# AD 379

## Tying resistances of full depth end plates

**Figure 1**  $\alpha$ , as calculated from P207 and P398

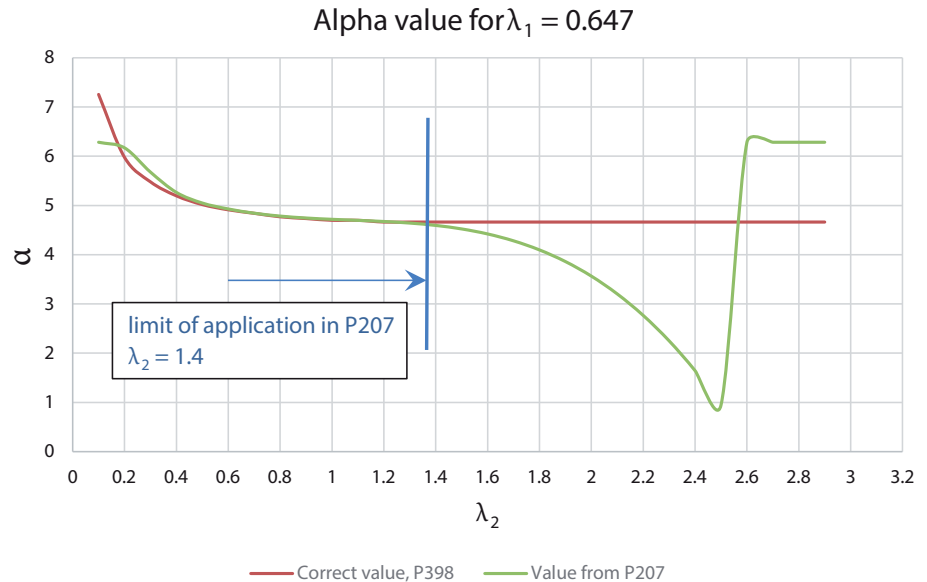
After some investigation, it has been found that the problem originates in the calculation of the alpha factor, for the bolts near the bottom flange. The alpha factor depends on the position of the bolt with respect to the flange and web and is taken from an “alpha chart” given in BS EN 1993-1-8:2005. This same chart is more commonly used in the calculation of moment resisting connections.

The several curves in the “alpha chart” may be represented by expressions. To calculate alpha for use in P358, SCI used the expressions given in P207 *Joints in Steel Construction: Moment Connections, 1995* (which covered connections designed in accordance with BS 5950-1). Whilst those expressions provide a good solution within the scope illustrated in P207, namely a maximum value of  $\lambda_2$  of 1.4, unfortunately when  $\lambda_2$  exceeds 1.4, the alpha value given by the expressions bears little resemblance to the correct value.

For interest, Figure 1 shows the relationship between the values calculated by the P207 expressions and the correct value from P398, for a particular value of  $\lambda_1$ .

A more comprehensive expression for alpha can be found in P398 *Joints in steel construction: Moment-resisting joints to Eurocode 3, 2013* (The Eurocode version of P207). It is strongly recommended that designers use this expression in their own calculations, rather than

Using the improved expression for alpha from P398 reduces the tying resistance for full depth end plates, in some cases, for beams deeper than 610mm. The reduction tends to occur with fewer bolt rows, when the lower bolt row becomes further from the bottom flange and  $\lambda_2$  increases.
